DESIGN CHANGE AFFECTING TENSIONING PULLEY 55443

TECHNICAL INFO NO. 1027

Image 1: 55443 – previous design

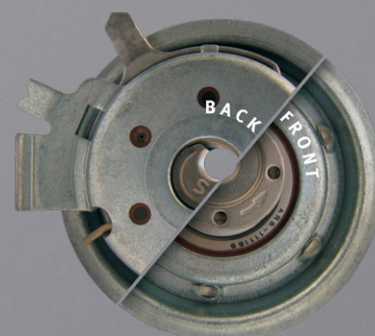
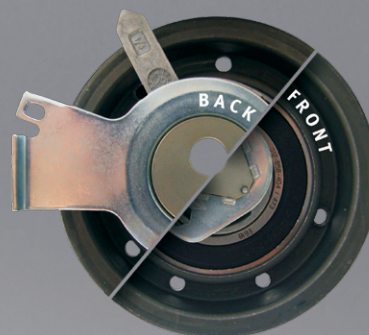
Due to the constant development of our products, the design of tensioning pulley 55443 has been changed.

The special tool (OE no. T10020) for turning the eccentric is no longer needed.

Please use a 6 mm allen key.

This Technical Information sheet shows the visible differences between the two versions from the front and back of each tensioning pulley.

We may have mixed stocks during the transitional phase. Both tensioning pulleys meet the technical specifications and can be used without restrictions on the specified vehicles.
